**CITY OF NEW BERLIN
PLAN COMMISSION MEETING
Monday, February 7, 2022**

(5) GK/NJ UA-2200060 Peter Ogorek with Perspective Design Inc. on behalf of the City of New Berlin - 15321 W. National Avenue - Use, Site and Architecture for the Phase II building addition and parking lot modifications for the New Berlin Activity and Recreation Center.

REQUEST: Use, Site and Architecture Approval for Phase II to construct a building addition and parking lot modifications for the Activity and Recreation Center located at 15321 W. National Avenue (Tax Key #: 1207-965-003).

**CITY OF NEW BERLIN
DEPARTMENT OF COMMUNITY DEVELOPMENT
PLAN COMMISSION STAFF REPORT**

CONCRETE CURB & GUTTER 18"

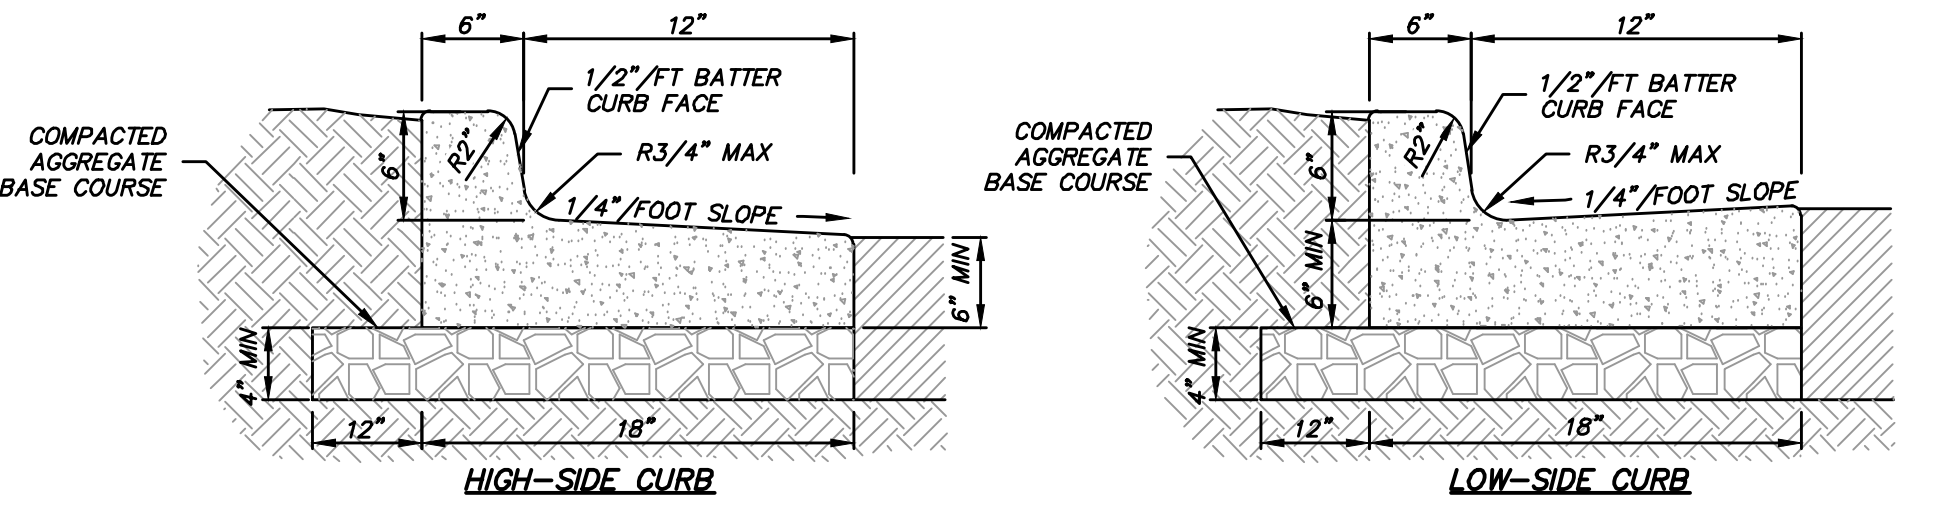
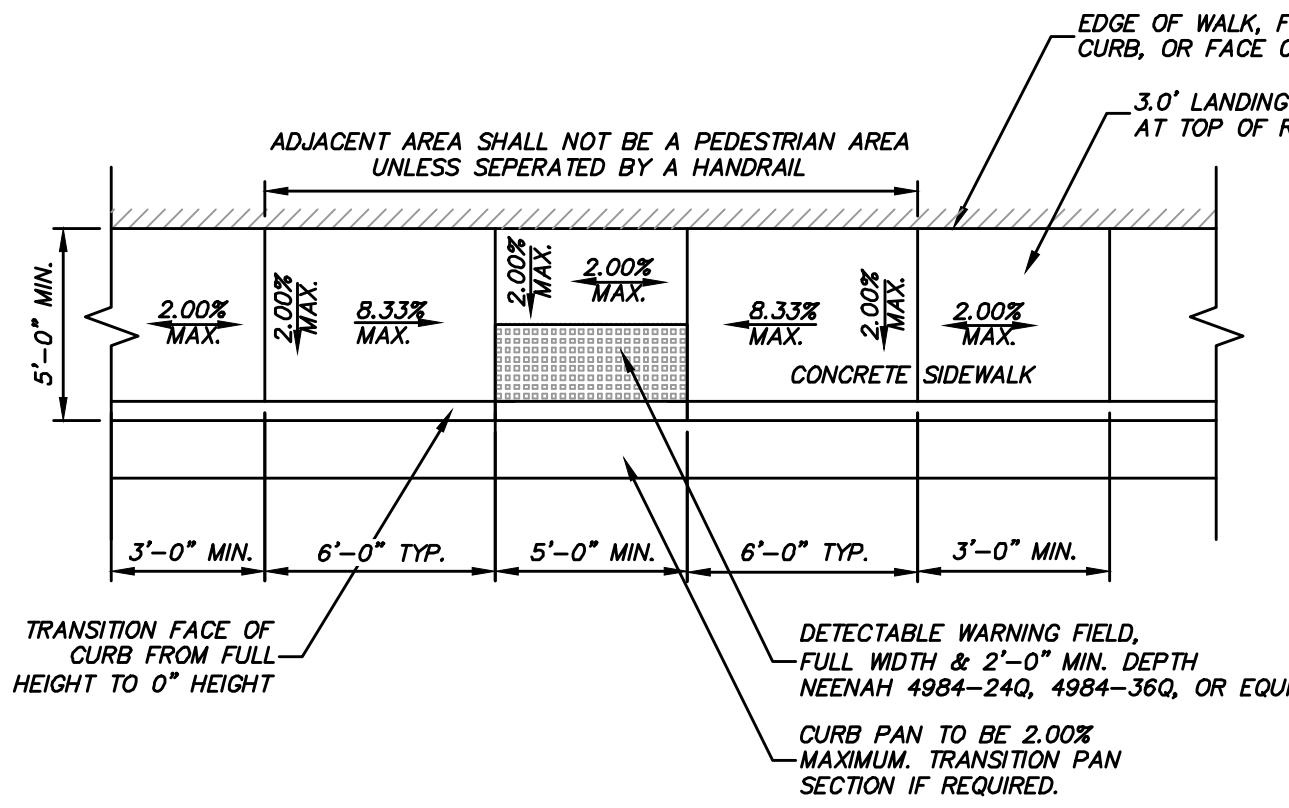
c. Sheet C2-500:

- i. Concrete Curb and Gutter 18": The City standard curb has a thickened flange. With the 18" curb the back of curb should be 14" and the flange 8.25" for low side curb and 7.75" for high side curb.
- ii. SD Asphalt Pavement: Use 5LT 58-28S for Surface Course. Use 4LT 58-28S for Binder Course.
- iii. The detail is showing MD Asphalt Pavement but there it is not called out for use on the plan. If it should be, please show where.
- iv. Concrete Sidewalk Section: Use a 5" thick concrete pavement over 4" crushed stone base.

2 WAUSAU TILE: TF4306 CONCRETE PLANTER

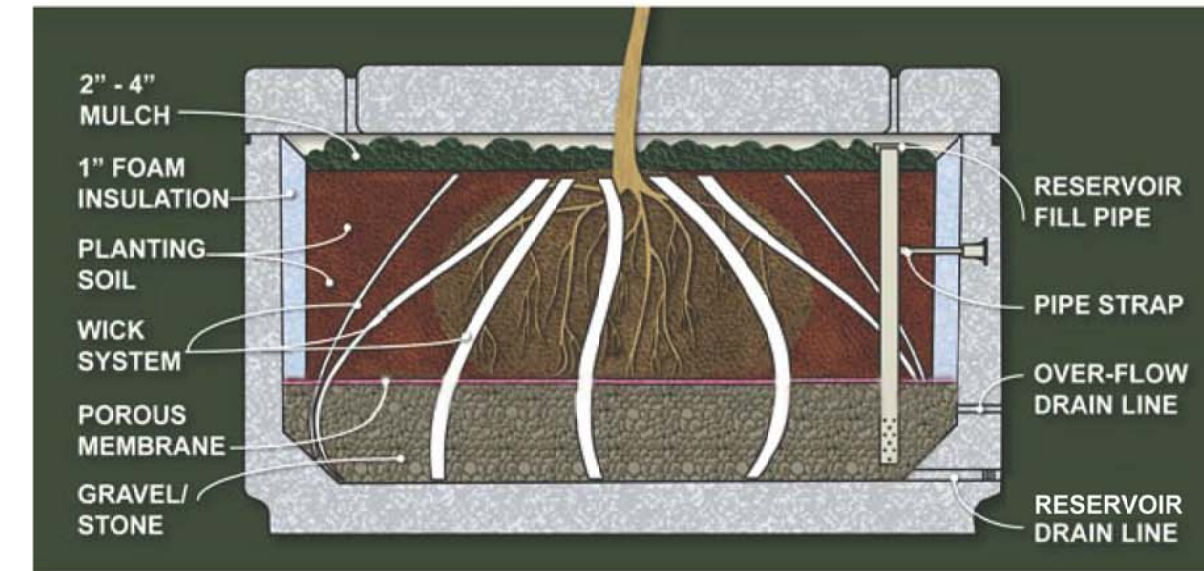
d. Sheet LSP1.3:

- i. Be aware that staff is discussing substituting the planters with other forms of entry way protection. They are considering sport ball themed bollards, large outcropping rocks, or a mix of these with a few planters.**
- ii. Remove the plantings just north of the 2 proposed bike racks and add additional bike racks to accommodate approximately 20 bikes.**
- iii. The plan shows planters and a tree off site just south of the fenced in play area. Discussions will be needed with Burghardts regarding this work.**
